REVISED AGENDA
SOUTHERN CORRIDOR REVIEW BOARD
Wednesday, June 5, 2013
3:00 P.M.

MEMORANDUM

RE: Parker's Convenience Store, COFA-4-13-5617

MEETING DATE:	May 8, 2013
PROJECT:	Parker's Convenience Store – Certificate of Appropriateness – Highway Corridor Overlay
PROJECT MANAGER:	Erin Schumacher, Senior Planner

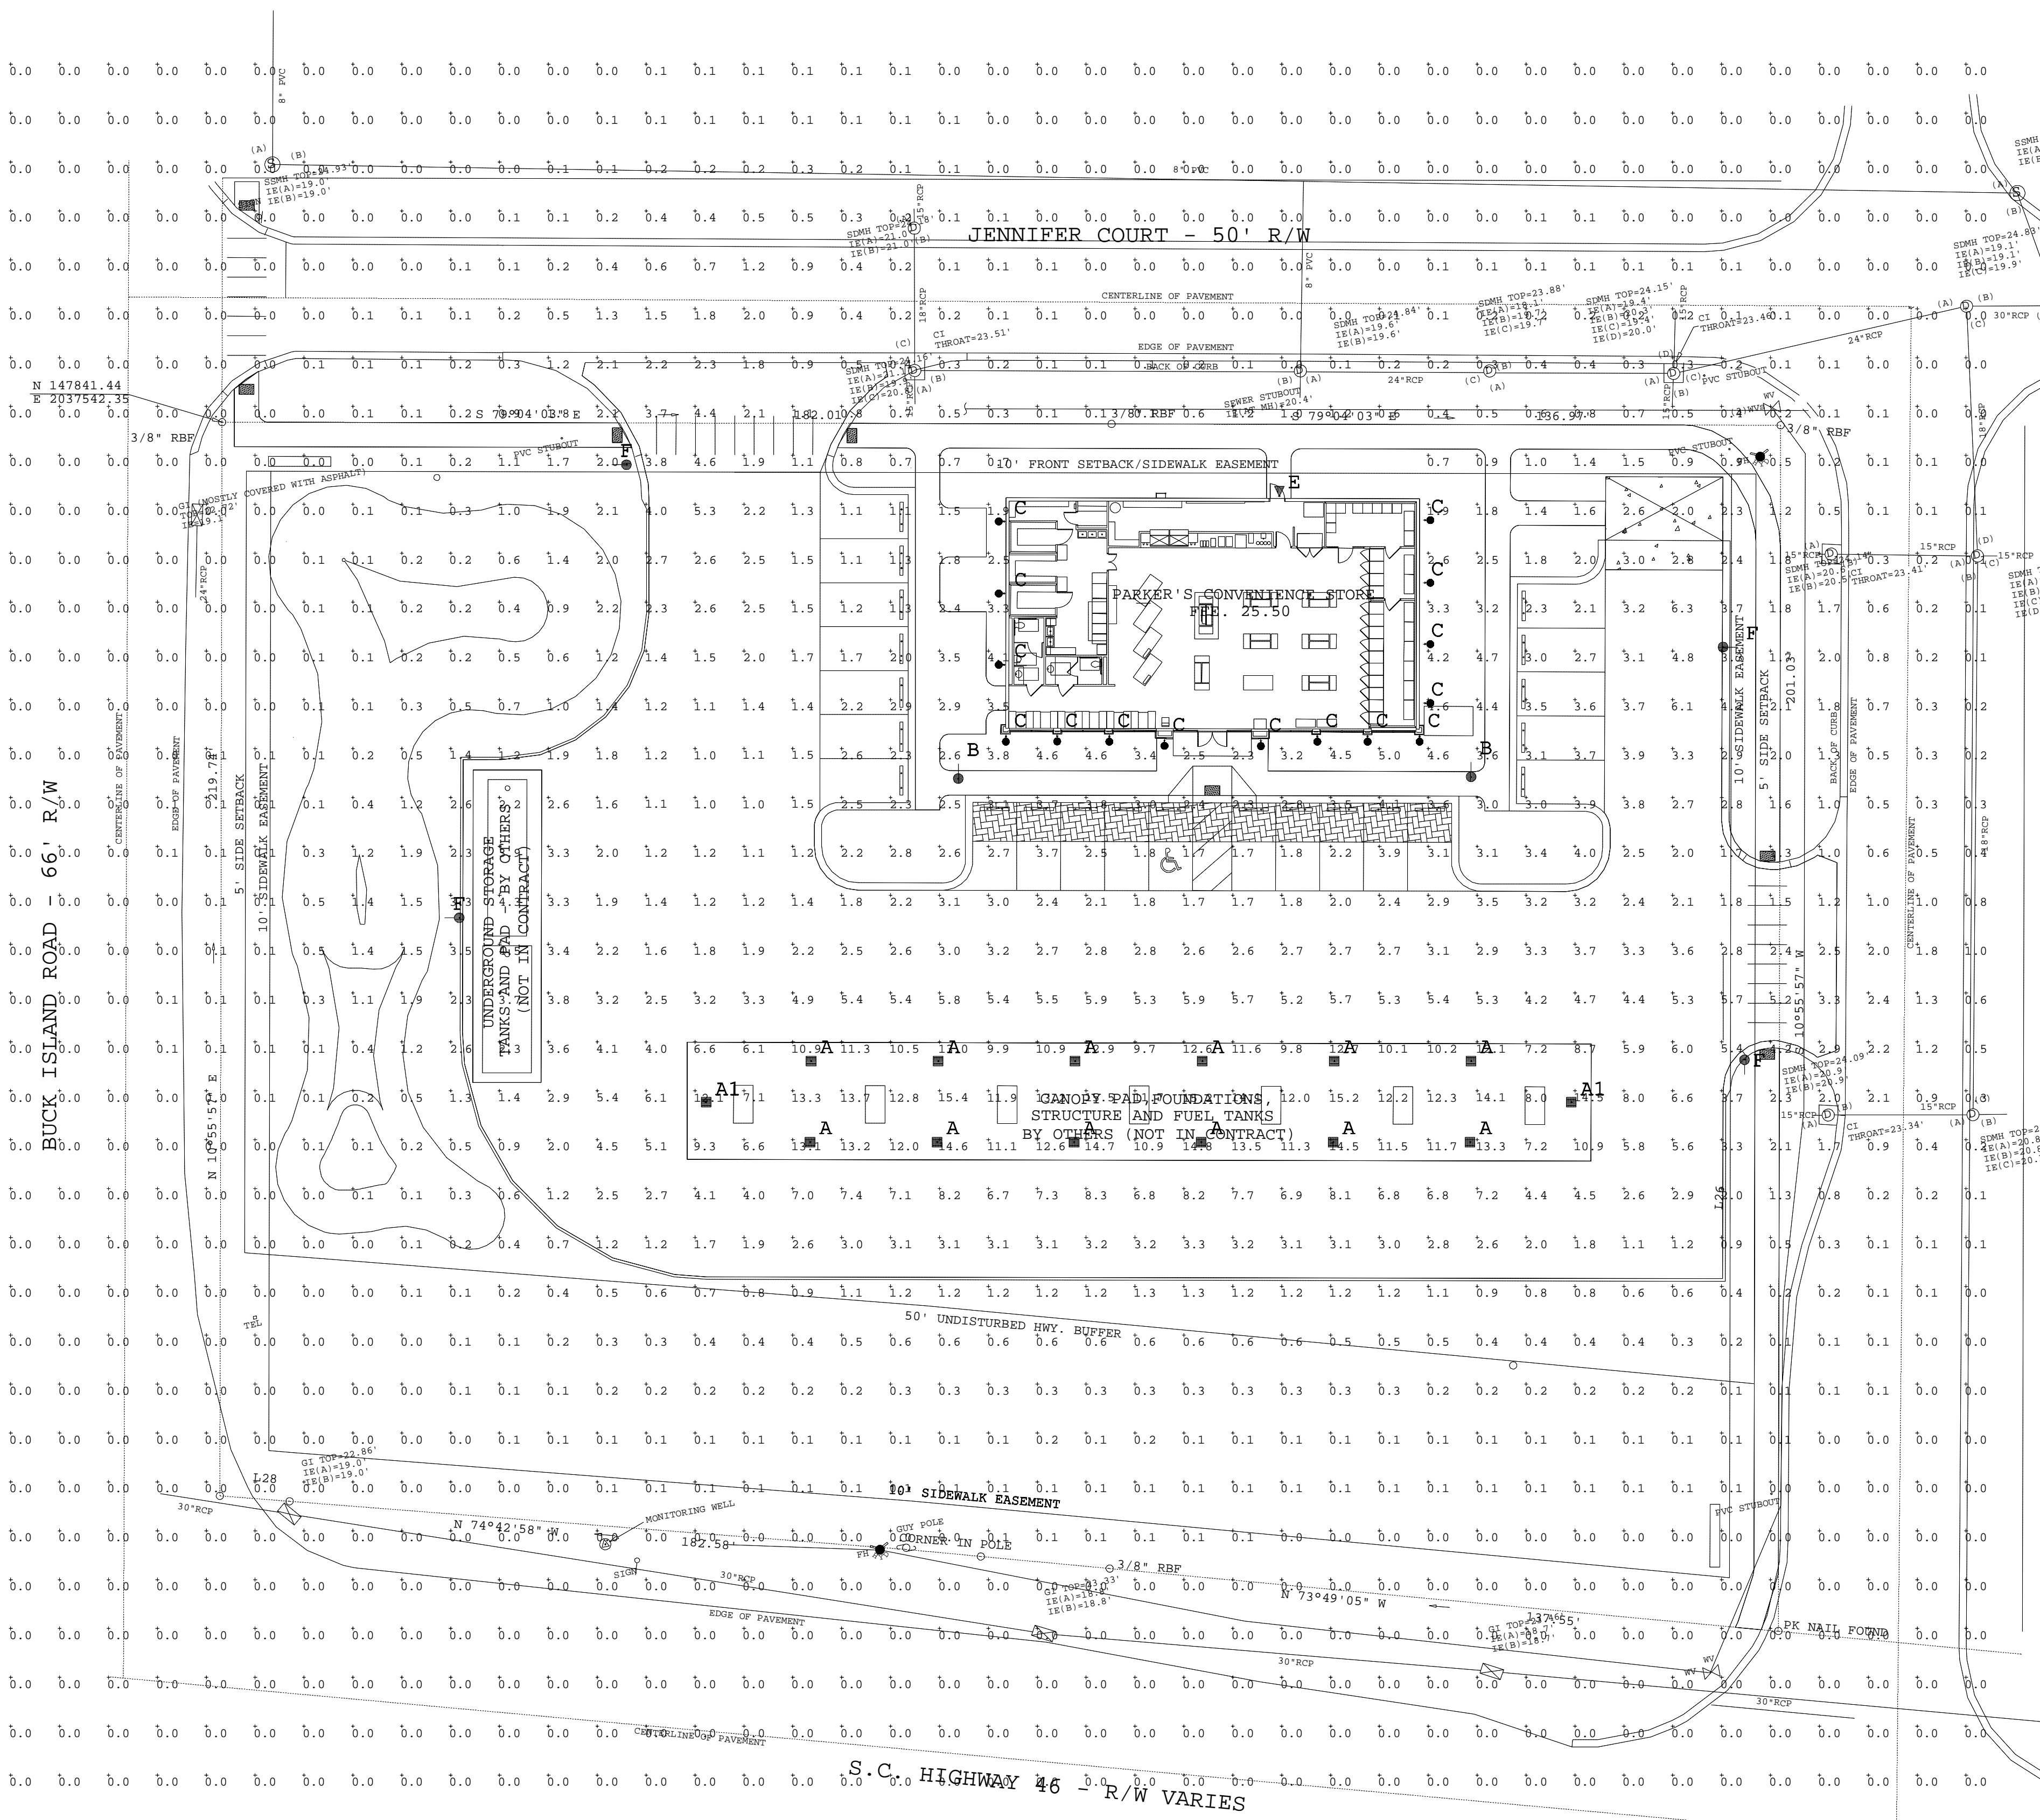
2. **Lighting.** Section 5.12 of the Unified Development Ordinance prescribes several items regarding lighting that must be met to be in accordance with the review criteria. The Applicant has supplied two updated and revised Lighting Plans that address the items of concern

outlined in the May 8, 2013 Staff Report. The first plan (Option A) proposes using a site lighting fixture that matches that of the May River Road Streetscape. The second plan (Option B) proposes using a site lighting fixture that is a "shoebox." Town Staff finds both revised Lighting Plans meet the requirements prescribed in Section 5.12 of the UDO. However, the Town of Bluffton has recently invested millions of dollars in the initial phase of the May River Road Streetscape and is currently working to continue the streetscape enhancements to the Buck Island Road intersection. The May River Road Streetscape incorporates, among other items, the Lifestyle CCS light fixture. It is important that development and redevelopment in this corridor are compatible with the public efforts to provide an attractive and cohesive gateway through Old Town Bluffton. As a result, Town Staff strongly encourages the Applicant to install Lighting Plan Option A, which utilizes the Lifestyle CCS fixture matching that of the May River Road Streetscape.

1. Per Section 5.3.4.H, the Applicant must submit a revised landscape plan for Town Staff approval showing that no more than 15% of plant material is of the same species. Town Staff will require the reduction in quantity of certain species from the Landscape Plan to achieve compliance and further recommend the Applicant maximize the variety and quantity of Oak and Magnolia species consistent with typical landscaping of the May River Scenic Byway.
2. The Applicant is strongly encouraged to install Lighting Plan Option A, which utilizes the Lifestyle CCS fixture matching that of the May River Road Streetscape.
